**PRELIMINARY REMEDIAL DESIGN REPORT  
FOR  
MEDLEY FARM SITE

CHEROKEE COUNTY  
SOUTH CAROLINA**

November 1992

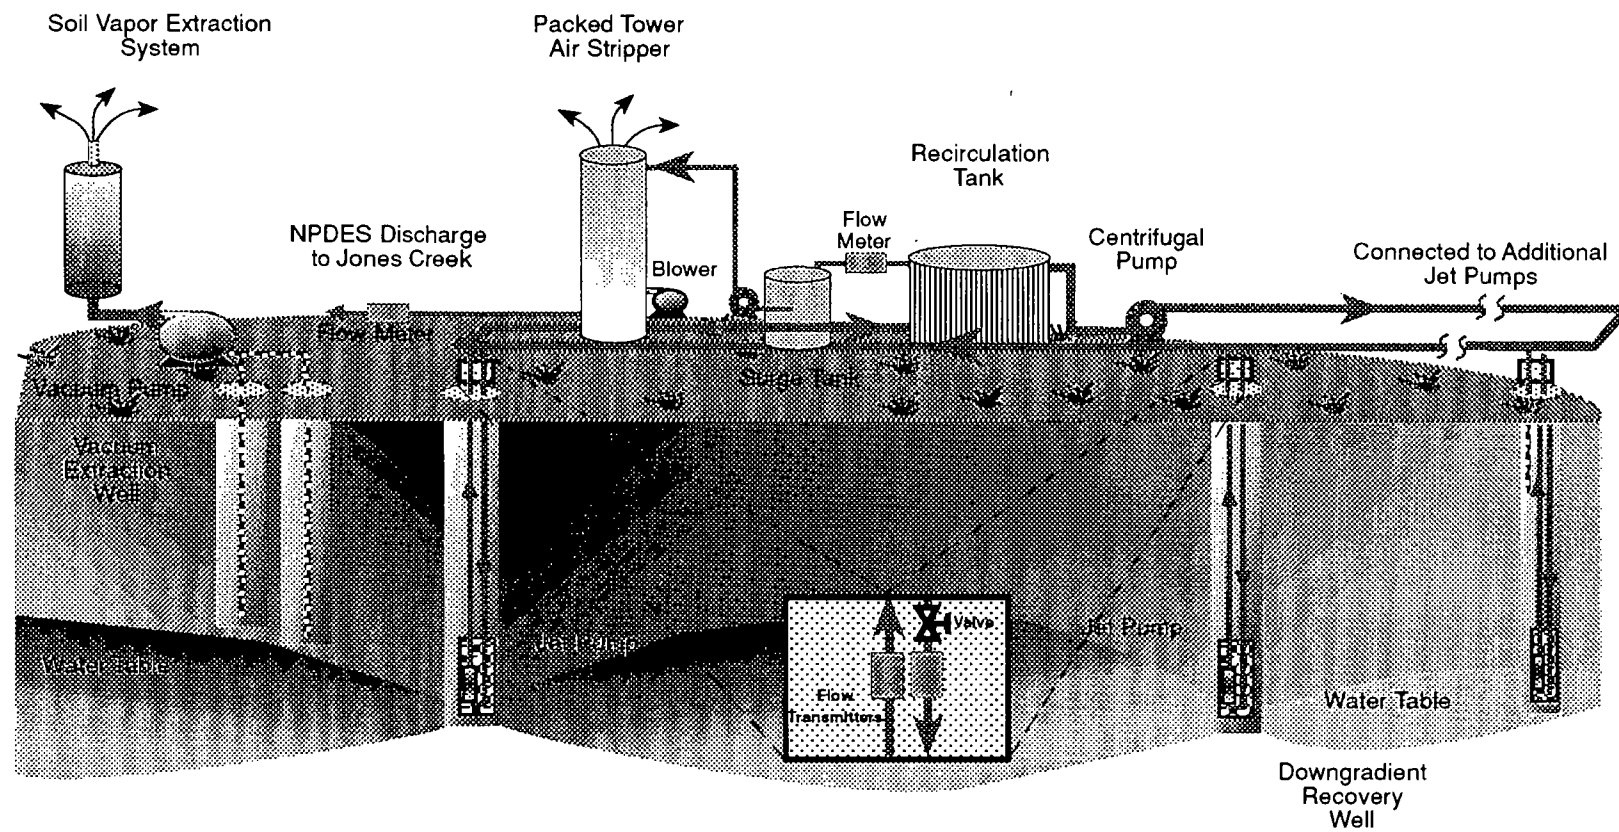
IF REQ'D: How much time do we  
lose?
